NOV_SCE_MYU_20220406-01_Revised

NOTICE OF VIOLATION

Energy Safety Inspection Report

Report Name: MYU_SCE_20220406-01_Revised

Item5GImg1: Overall pole

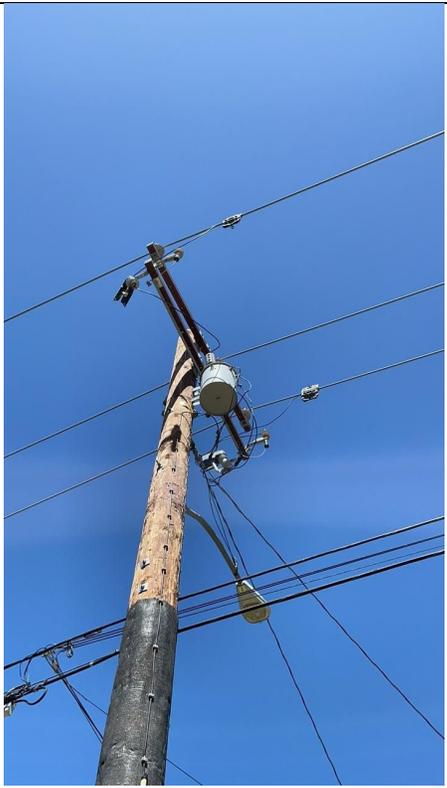
Item5IA1Img1: Missing vibration damper
